Addendum #1

Date: November 19, 2021
Project: **Offsite Waterline Supply**
Lukachukai Community School Replacement
Location: Indian Route 12
Lukachukai, AZ 86507

RE: LCS & NHA Offsite Waterline, Lukachukai AZ – NTUA-HQ Review @ 'Pre-Final' Submittal

SHEET NO.
C-08

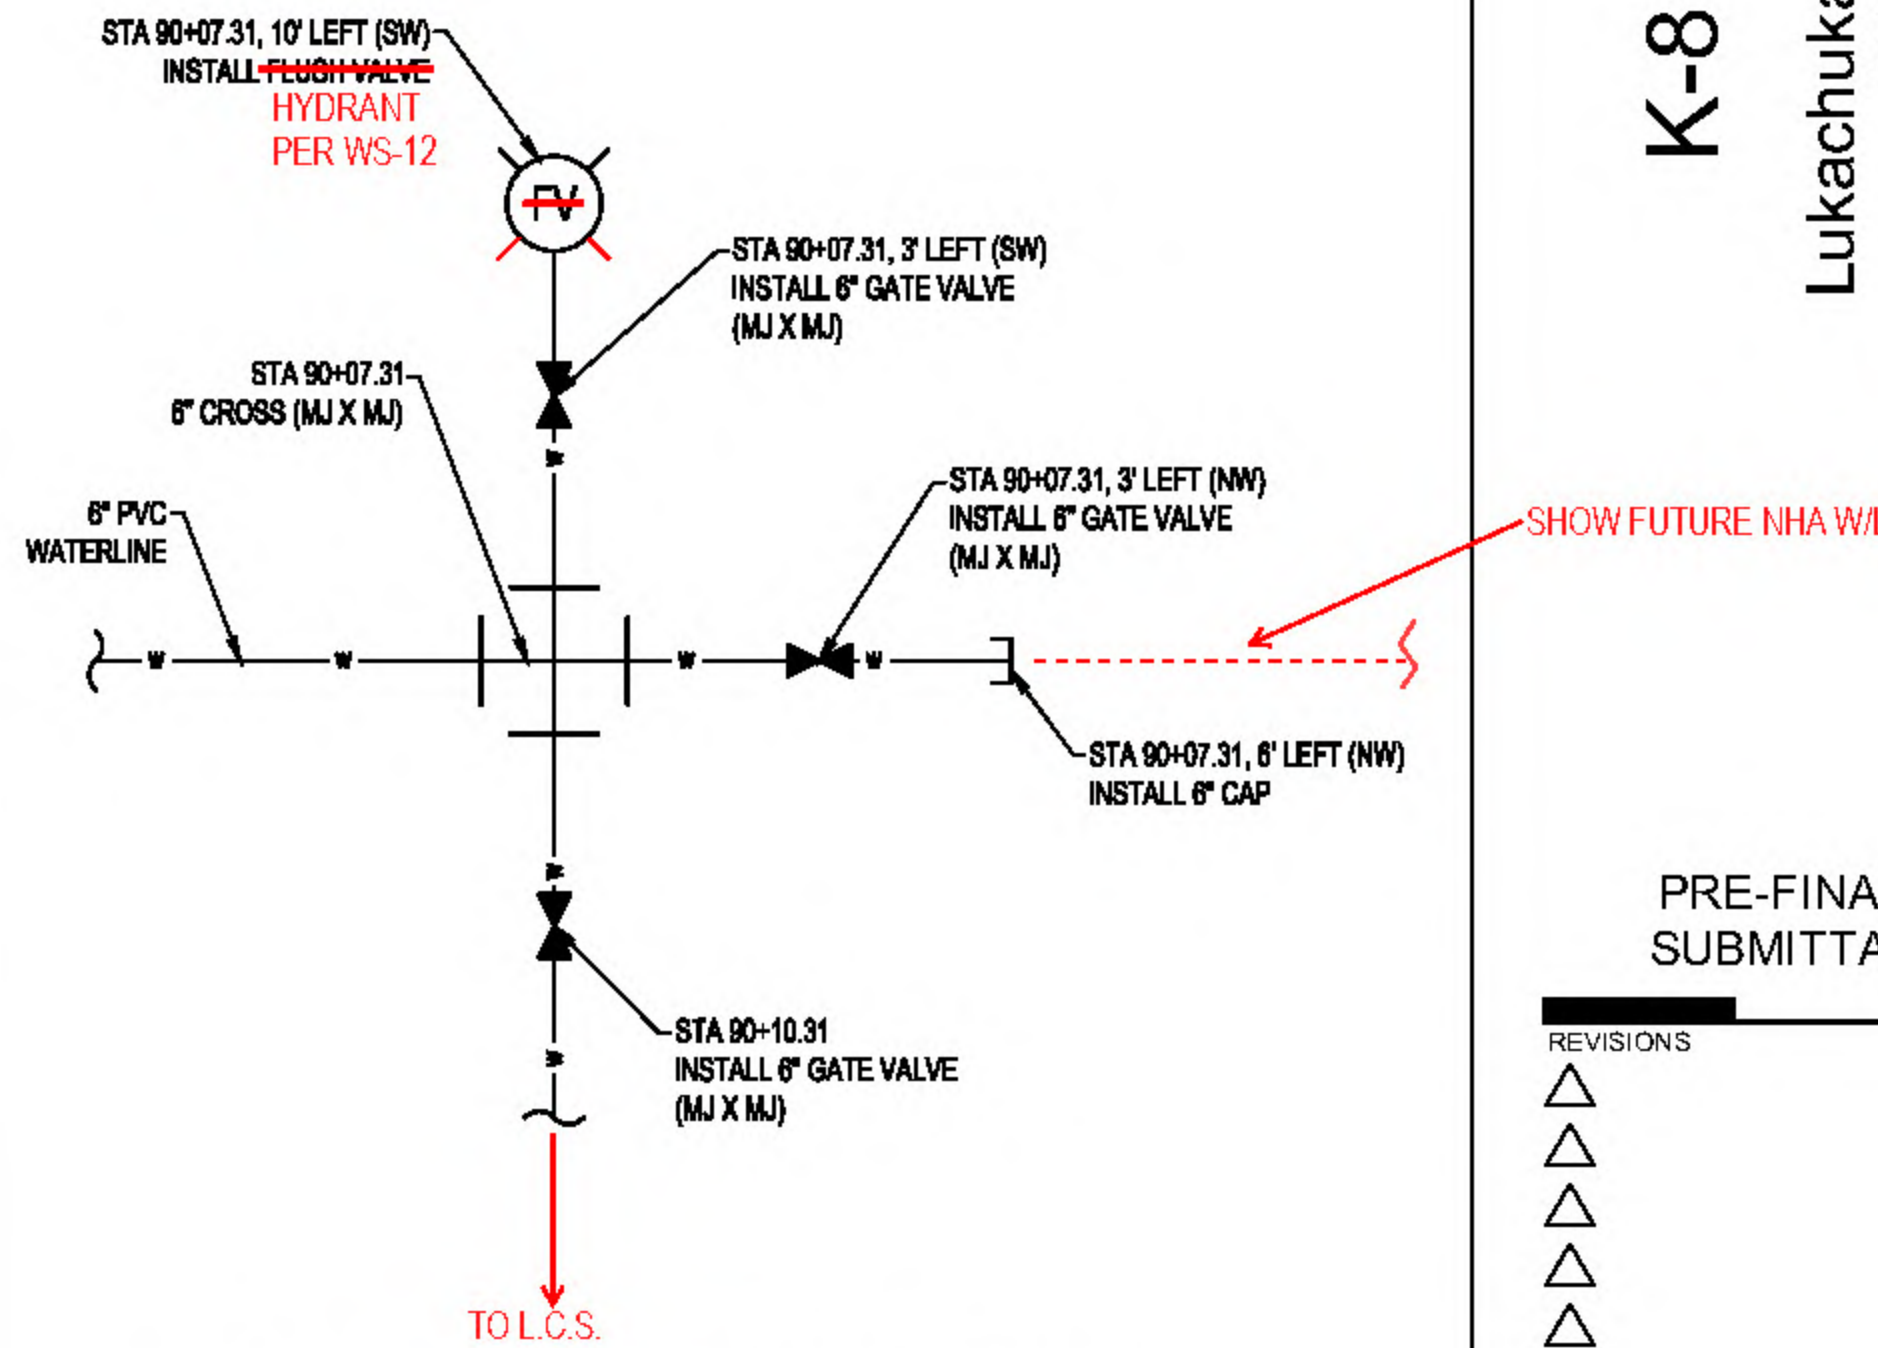
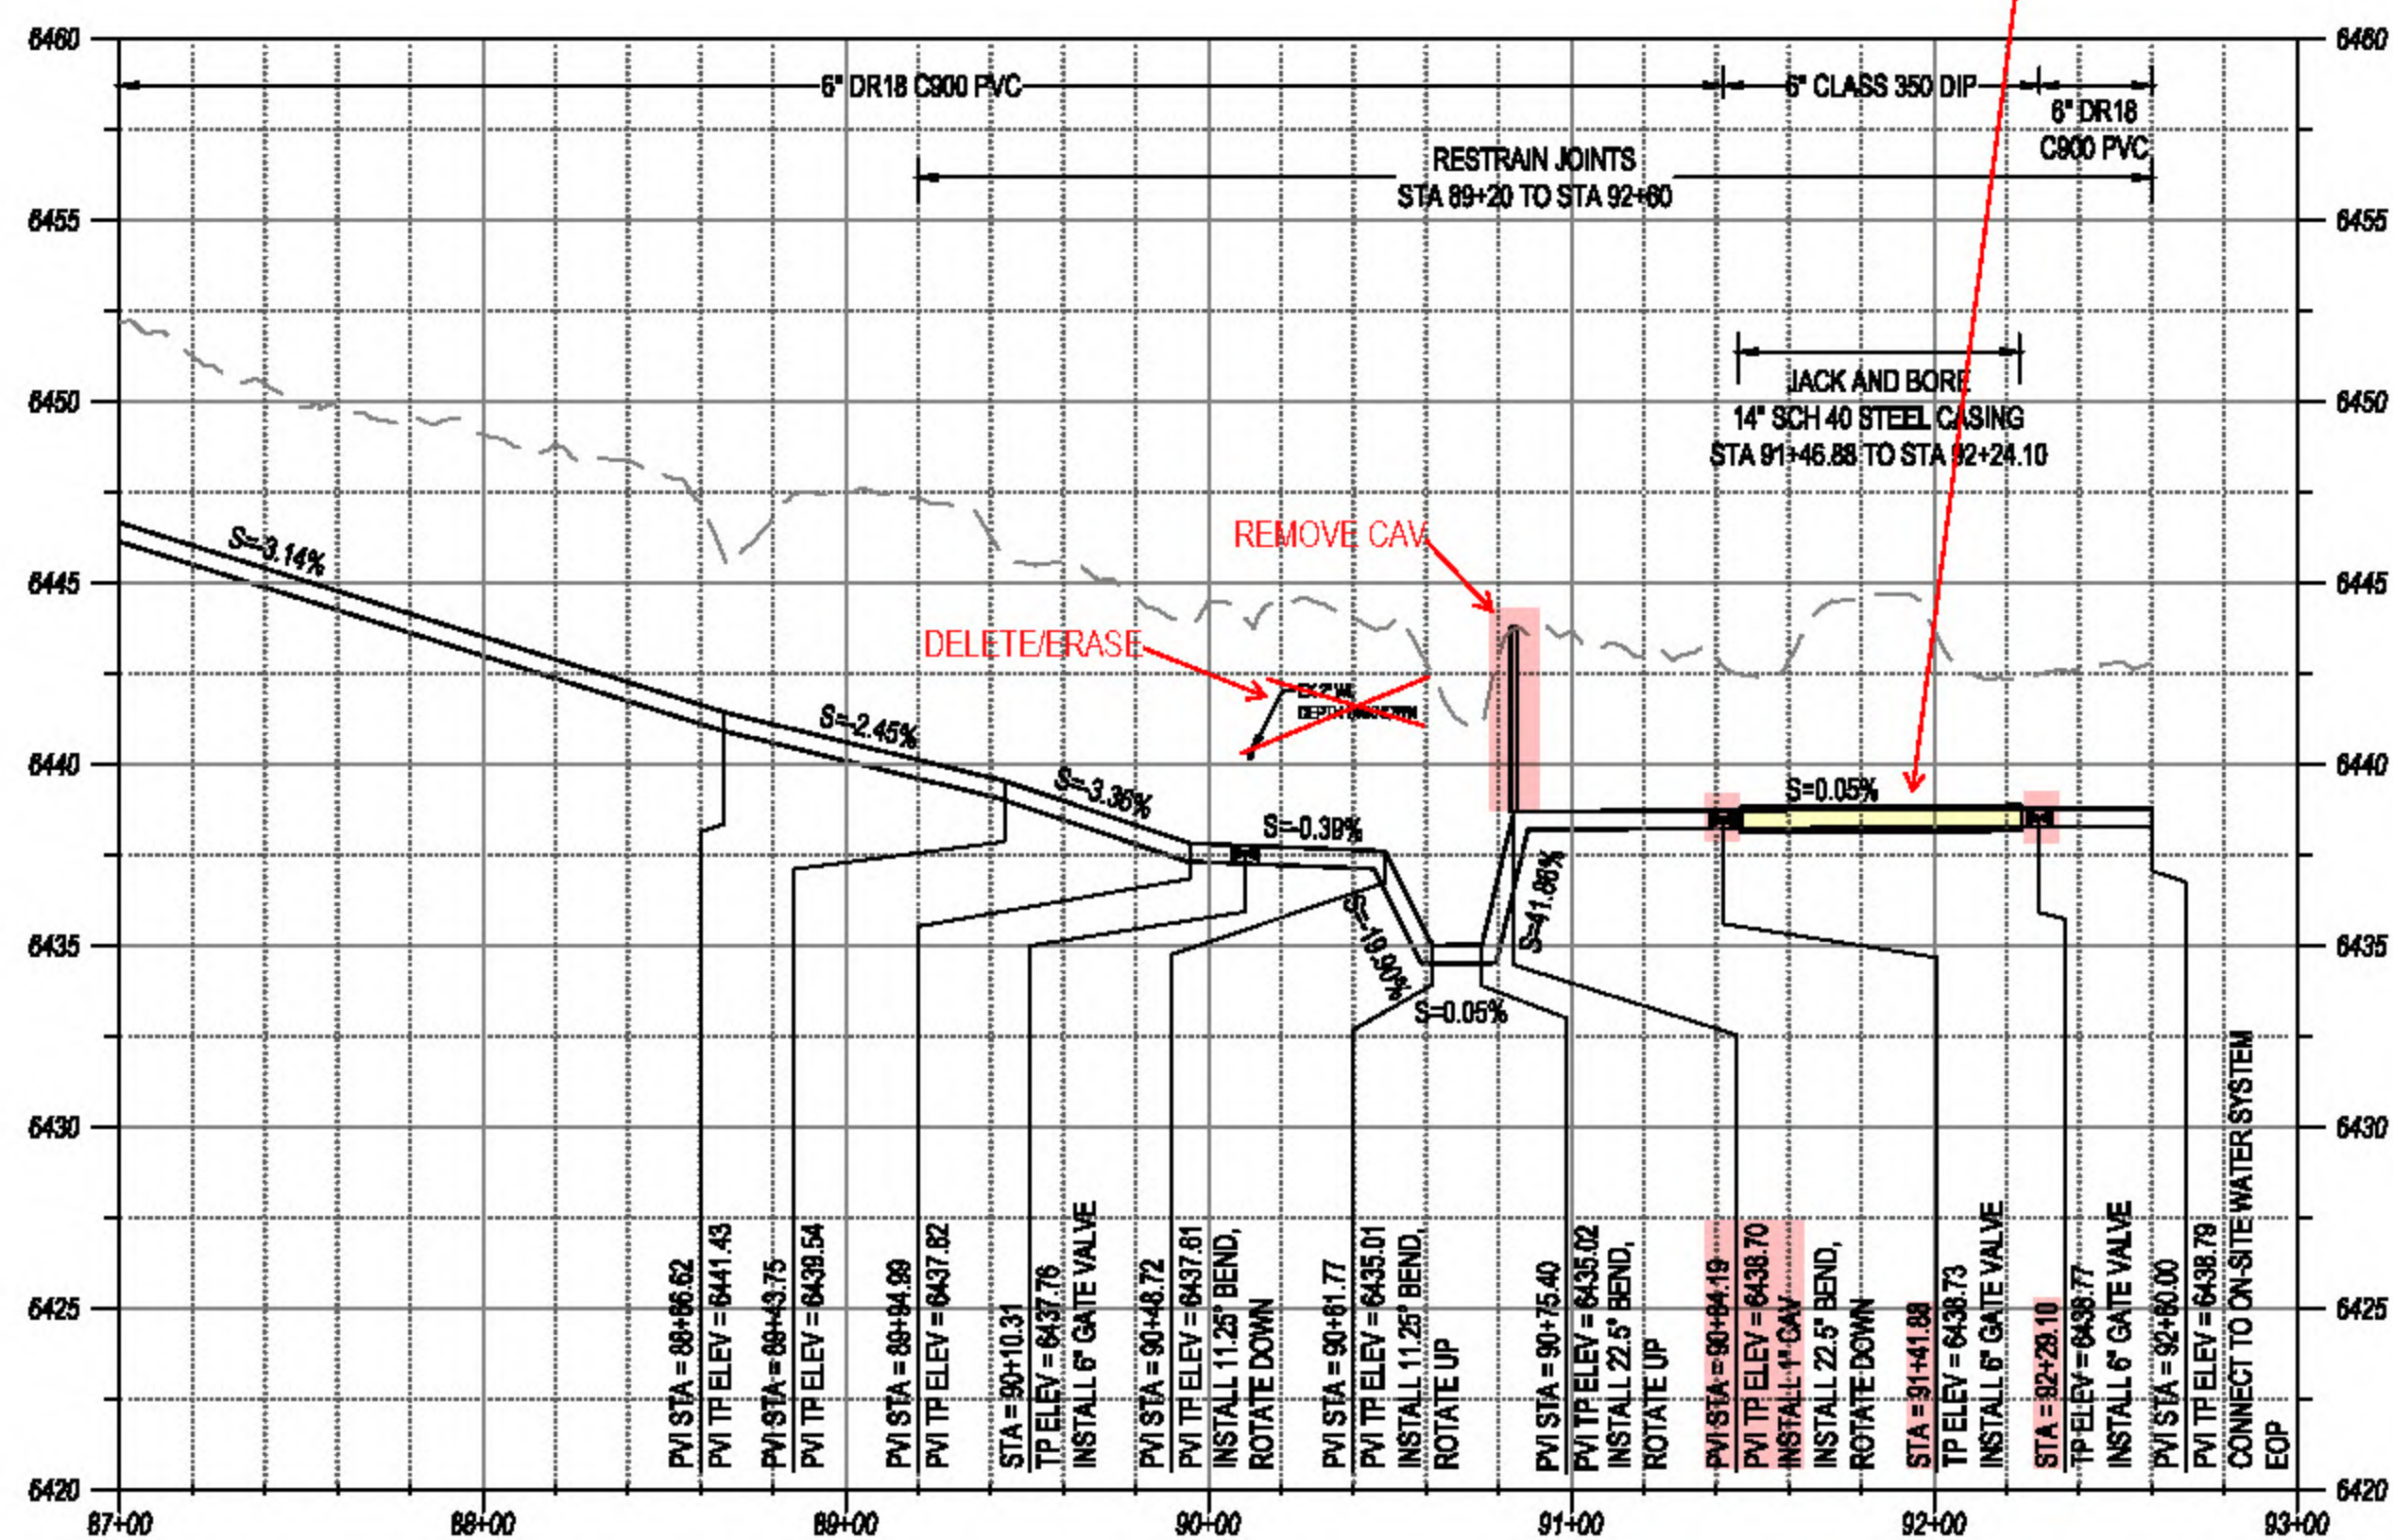
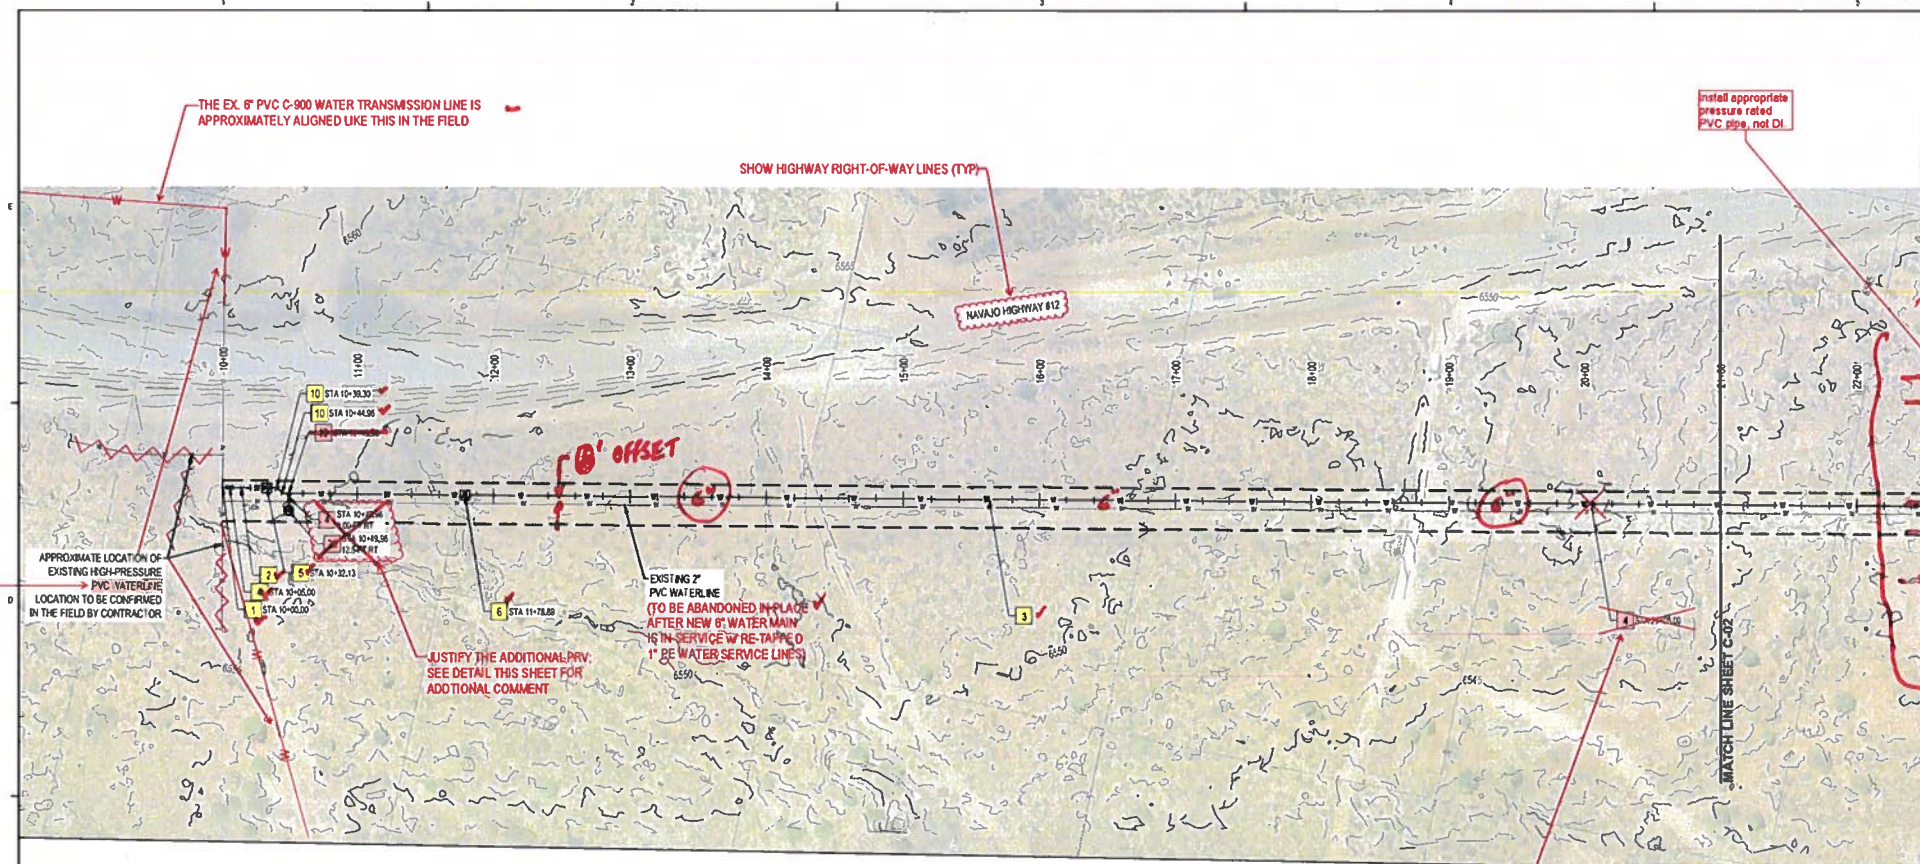
1. Non-existing 2" PVC W/L: Delete/erase the shown ex. 2" waterline alignment that is shown from Sta. 87+00 to Sta. 92+60. This does not exist in the field.

2. New 6" PVC C900 W/L alignment: From Sta. 87+00 to Sta. 92+60, align the new 6" water main at the centerline of the new 30-ft water easement/ROW.
3. General Comment: Show the highway right-of-way lines on each plan sheet (typ).

4. Show the requested 100-ft expanded road crossing for boring operations. Coordinate this expanded crossing permit w/ the BIA Chinle Agency DOT.
5. Show and callout the planned steel casing from highway ROW-to-ROW as shown.

6. Planned Gate Valves at End-of-Casing locations: Move/revise the road crossing gate valve locations to 3-ft min. outside highway ROW lines, as shown.

7. Plan Keyed Notes #14 (Bore Pit): On the plan, show/label the bore pit descriptions on the keyed note (Launch Pit/Receiving Pit) as shown.
8. Sta. 90+84.19 (Proposed CAV): Remove this CAV as it will not be required at this location.

9. Callout new Hydrant also on plan view at Sta. 90+07.31 LT. Flush valve not approved.
10. Callout the future NHA water main downstream of the 6" cross area. Question: Who will be designing this offsite NHA waterline? Coordination may be required w/ the NHA and its client engineer.

11. Keyed Notes: Make corrections to the key note descriptions as shown on the plan sheet.

1. Edit/add the additional minor text items/labels on the detail, as shown

1. Delete/erase the shown ex. 2" waterline, as it does not exist here.

DRAWN BY JTL
REVIEWED BY NDR
DATE 09/03/2021
PROJECT NO 20-7002.001
DRAWING NAME
LCS WATERLINE
SUPPLY
PLAN & PROFILE
STA 65+00 TO STA
76+00
SHEET NO
C-06

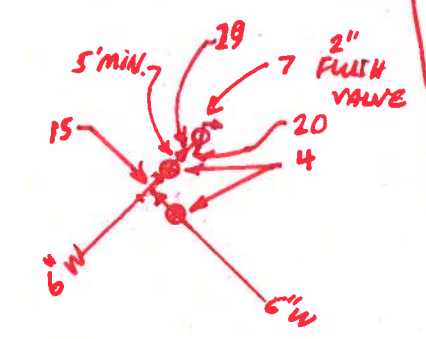
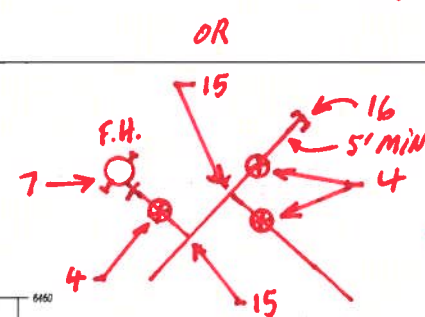
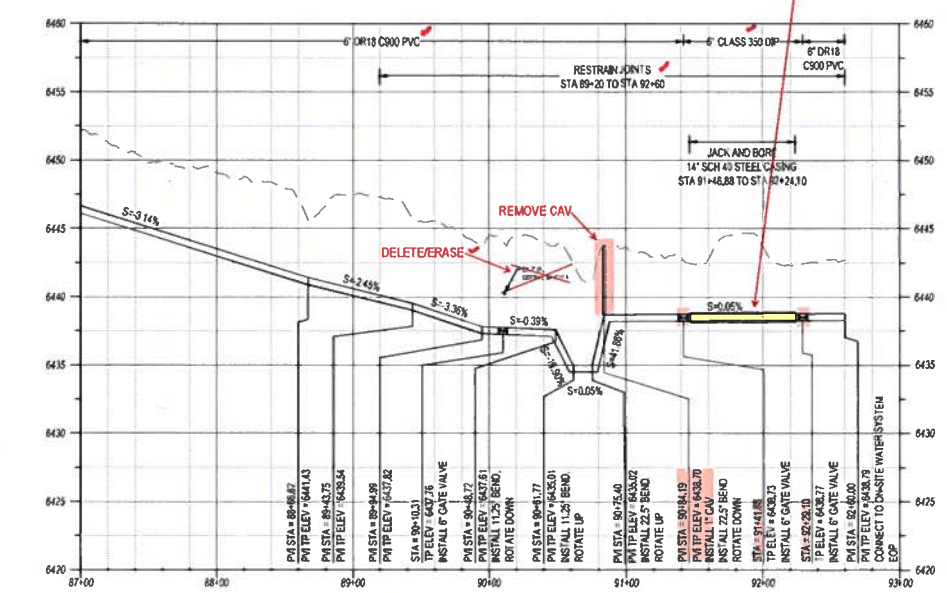
SHOW HIGHWAY RIGHT-OF-WAY LINES (TYP)

MOVE G.V.'S TO OUTSIDE HIGHWAY ROW LINES (TYP)

DETAIL 1 (PREFERRED BY GARY.)

SHEET NO
D-04

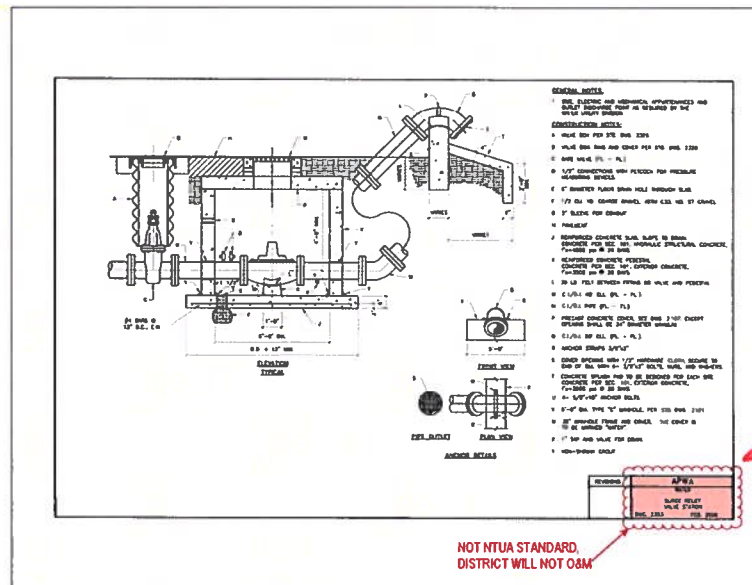
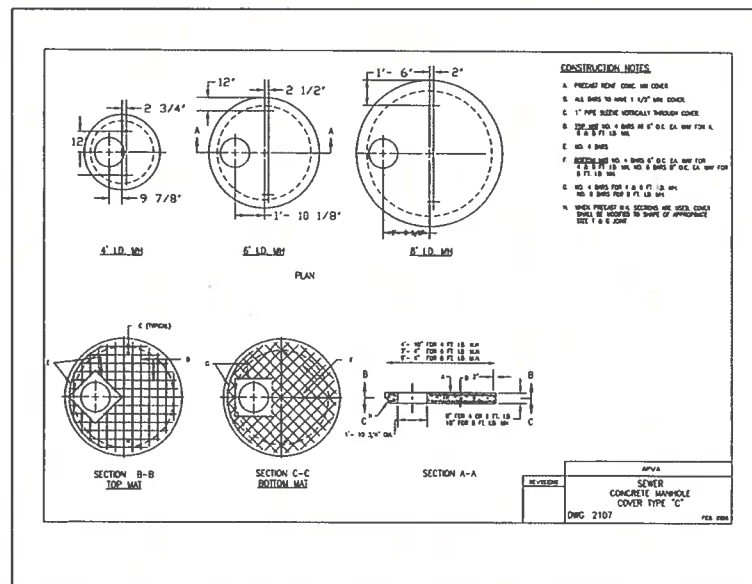
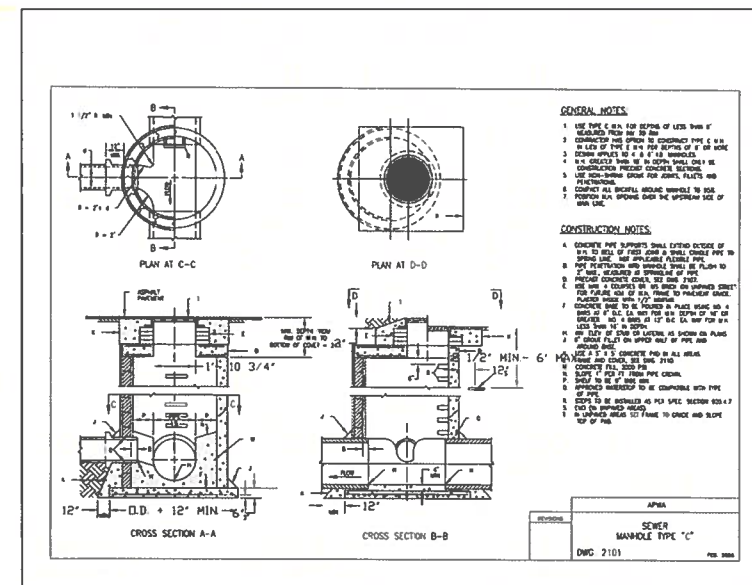
NEED TO SHOW IF SPV IS NEEDED.

WHERE ARE THE SEWER MANHOLES GOING TO BE USED - NOT TO BE USED ON WATERLINE.
